01-025/12 - 2009-2012 MAZDA6 - EXHAUST LEAK NOISE FROM REAR OF VEHICLE

EXHAUST LEAK NOISE FROM REAR OF VEHICLE

Bulletin No: 01-025/12

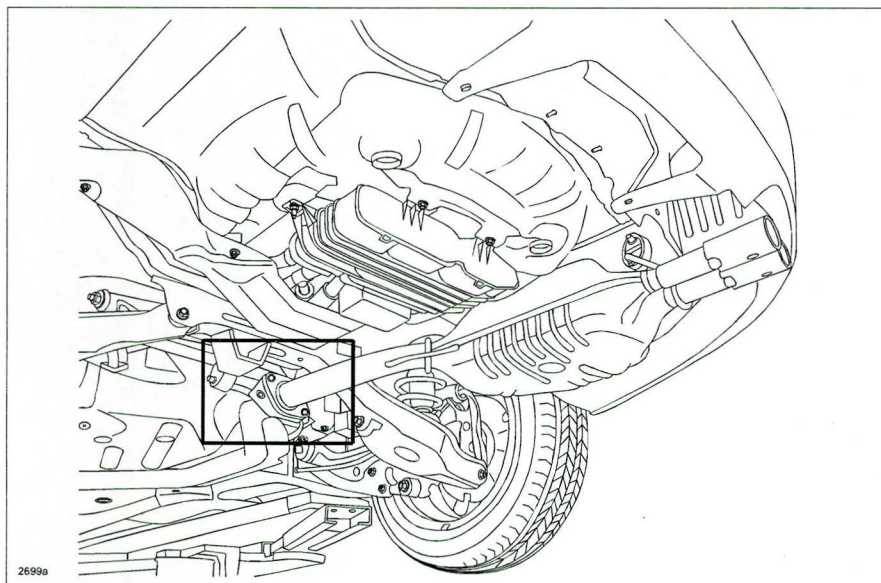
Some vehicles may exhibit an exhaust leaking noise from the rear of the vehicle. The noise may be caused by a gap between the exhaust hanger bracket and flange, which allows moisture to enter and cause the exhaust studs to rust and possibly break off.

The welding location of the exhaust hanger bracket and flange has been changed to ensure the hanger bracket and flange are flush with no gaps to allow moisture intrusion.
